STAFF REPORT
COMMUNITY DEVELOPMENT DEPARTMENT

SUBJECT: FP-2021-0006
Pine 43 No. 4

Final plat consisting of two (2) buildable lots and one (1) common lot on 27.48 acres of land in the R-40 zoning district for the fourth phase of Pine 43 Subdivision.

B. Final Plat (dated: 2/11/21)

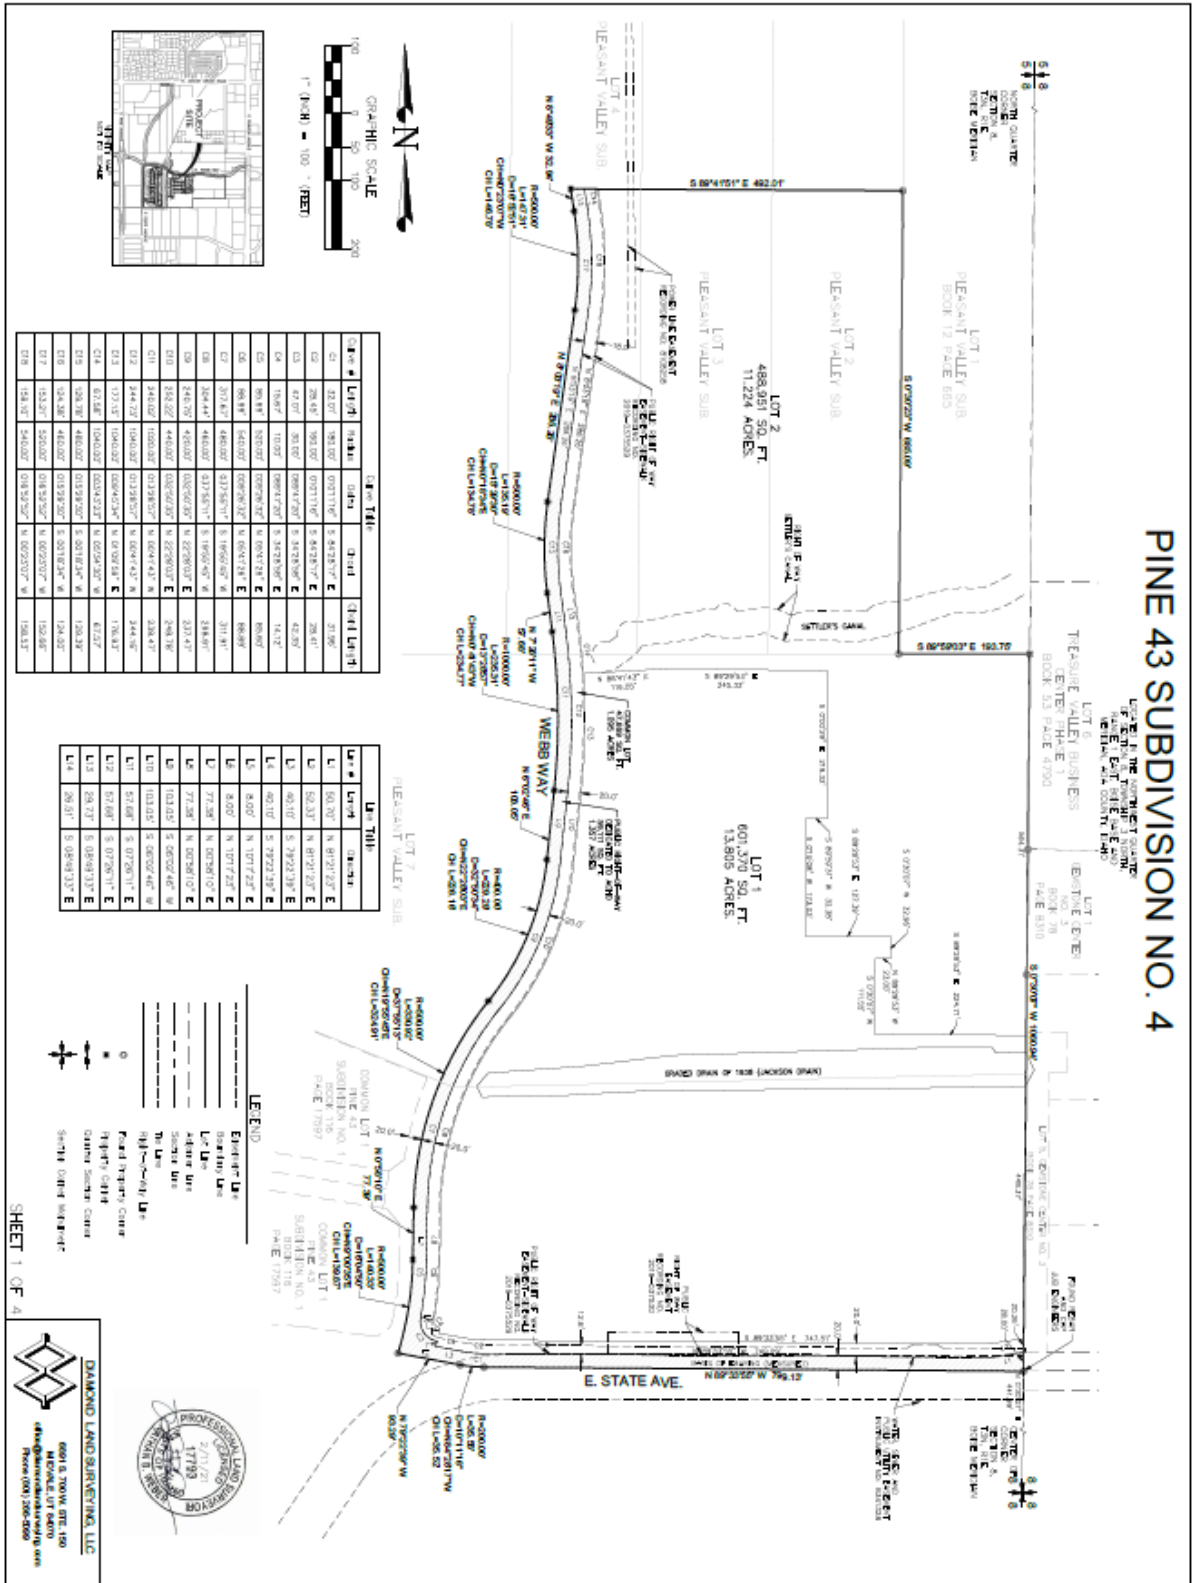
1. Applicant shall meet all terms of the approved annexation (AZ-07-006), Development Agreement (Inst. #108022893, amended Inst. #2018-000751 (superseded original agreement), rezone and preliminary plat (H-2017-0058) applications approved for this site.
2. The applicant shall obtain the City Engineer's signature on the subject final plat within two years of the City Engineer's signature on the previous phase final plat; *or* apply for a time extension, in accord with UDC 11-6B-7.
3. Prior to submittal for the City Engineer's signature, have the Certificate of Owners and the accompanying acknowledgement signed and notarized.
4. The final plat prepared by Diamond Land Surveying, LLC., stamped by Nathan B. Weber, dated: 2/11/2021, included in Section V.B shall be revised as follows:

- a. Note #7: Include the recorded instrument number of the Development Agreement (#2018-000751).
- b. Note #8: Include the recorded instrument number of the ACHD License Agreement.

- c. Include a lot number for the common lot (i.e. street buffer) along with a note stating the common area will be maintained by the homeowners' association in accord with UDC 11-3B-7C.2a.

- d. The internal common open space and site amenities for the development shall be located on a common lot or an area with a common maintenance agreement as set forth in UDC 11-3G-3D.1.

- e. Depict a 10-foot (instead of 8-foot) multi-use pathway along the north side of the Jackson Drain as required by the Park's Dept. in accord with the Pathways Master Plan per H-2017-0058 (condition #1.1.2e).

- f. Depict 8-foot wide parkways along N. Webb Way and E. State Ave. consistent with that shown on the landscape plan.
 - g. Depict NMID's easement for the Jackson Drain.

- A copy of the revised plat shall be submitted for City Engineer signature.*
5. The landscape plan prepared by Dekker Perich Sabatini, dated 6/15/2018, included in Section V.C, shall be revised as follows:
